Town of Parker Community Development Department  
Development Review Division  
Attention: **Julia Duncan**

Application Type: **Site Plan**  
Status: **First Referral**  
Application Name: Auburn Hills Centre L4 - Circle K- Gas and Convenience Store  
Case/AP#: **SP21-138**  
Referral Received: April 21, 2022  
Comments Due: May 19, 2022

<b>TOWN OF PARKER - FIRE/LIFE SAFETY:</b>	<b>R REVIEWED FOR CODE COMPLIANCE; REVISIONS REQUIRED</b>
-------------------------------------------	-----------------------------------------------------------

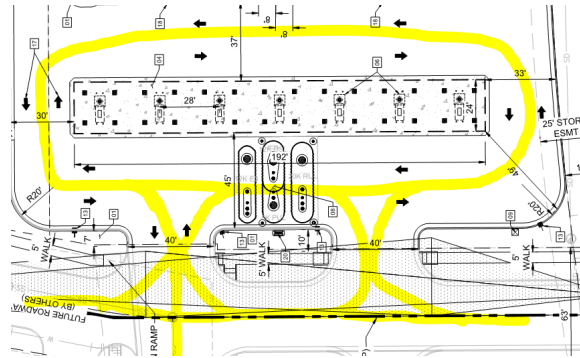
8. The applicant shall provide an auto turn analysis indicating that apparatus can navigate all portions of this site (both sides of the gas canopy); NO PARKING – FIRE LANE signage is required for any portion of the access where the 20-foot clear width requirement cannot be met. This is applicable for the loop around the canopy

as well as for each entry. The access on each side of the canopy shall meet his requirement with no portion of the canopy encroaching into the required fire lane access road. See below for the areas required to be included in the auto turn analysis and address when resubmitting: *Satisfied; applicant has noted/acknowledged/addressed with second submittal.*
